PMESD-409128759  
Sup: 4-19-2004

**RE: Amendment to Administrative Order NSL-4750 (BHL) (SD)  
Indian Hills Unit Well No. 45 (API No. 30-015-32338) Horizontal Re-Entry  
806' FNL & 1,010' FEL, Sec. 28, Township 21 South, Range 24 East (SHL),  
339' FSL & 1,148' FEL, Sec. 21, Township 21 South, Range 24 East (BHL)  
Indian Basin Upper Pennsylvanian Associated Pool**

## WELL PROFILE DATA

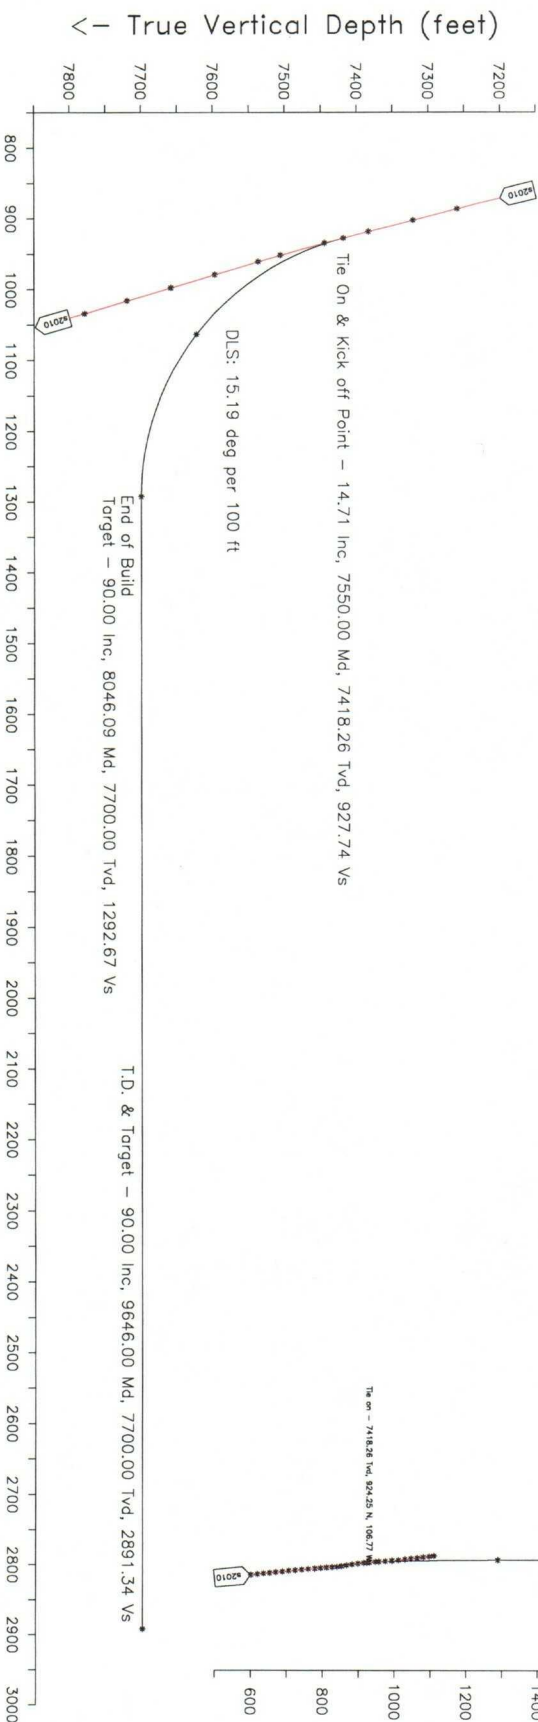
I am now processing a non-standard location order for your application filed on March 29th. From your application the proposed directional plan anticipates the Upper Pennsylvanian formation will be penetrated at a sub-surface location 119' FSL & 1080' FEL of Section 21.

At what depth is this expected to occur?

In response to your e-mailed question regarding Marathon's non-standard location application for the horizontal Indian Hills Unit #45 well, I have provided the penetration depths. As you mentioned, we anticipate the Upper Pennsylvanian formation to be penetrated at a sub-surface location 119' FSL & 1,080' FEL of Section 21. This corresponds to the following approximate depths:

- -3,750' SSTVD
- 7,700' TVD
- 8,954' MD

As you know, because we are planning to drill this well as a horizontal, the MD footage will be higher than our "typical" Upper Penn. wells. I hope this provides you with the information you need, but if not please do not hesitate to let me know.
